No. 89-21

MerCarb Flooding and/or Rough Idling MCM 2.5L, 3.0L and 3.7L Engines

Figure 1.

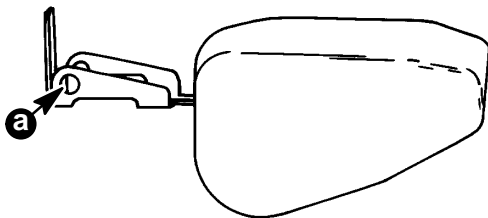
Inspect gasket under seat fitting. If gasket is "cup shaped" replace it. The gasket "cups" because the O.D. of some gaskets were too large. (Figure 1) Order new needle/seat.

a - Cupped Gasket (Oversized O.D.)

b - Flat Gasket (Correct O.D.)

Figure 3.

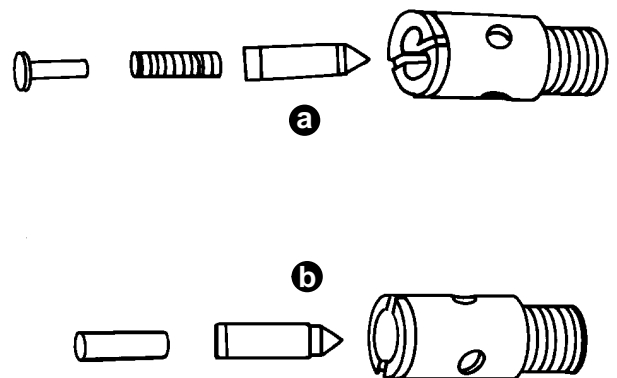
If all the preceding specifications and components check out okay and there still is a flooding and/or rough idle condition change to the spring loaded needle and seat P/N 3302-9029 (Figure 3). This needle and seat will help control flooding in MerCarbs that may be affected by the inherent vibration characteristics of a 4 cylinder engine.

Float level specification for spring loaded needle and seat is 9/16 in. (14mm). Raise float and allow it to fall on spring. DO NOT force float downward by hand.

a - Spring Loaded Needle & Seat P/N 3302-9029

b - Solid Two Piece Needle & Seat P/N 3302-9407

Figure 4.

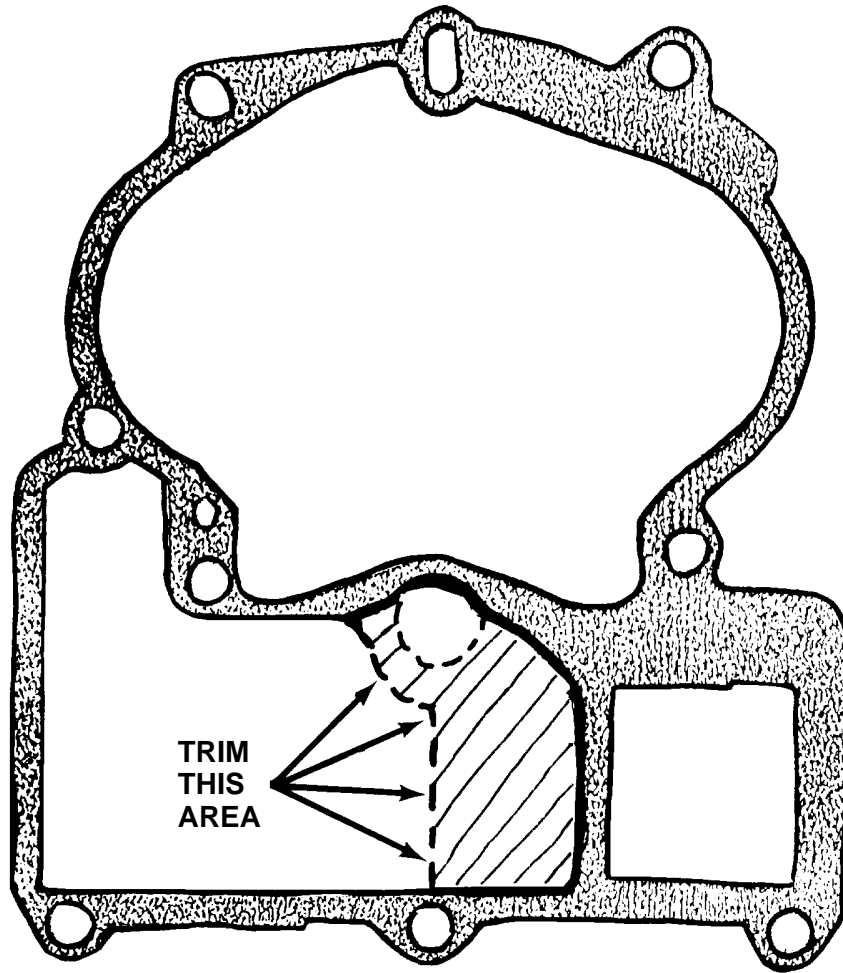
When using the spring loaded needle and seat, the carburetor cover gasket must trim for float clearance as shown (Figure 4). A new carburetor cover gasket will be available in early fall.
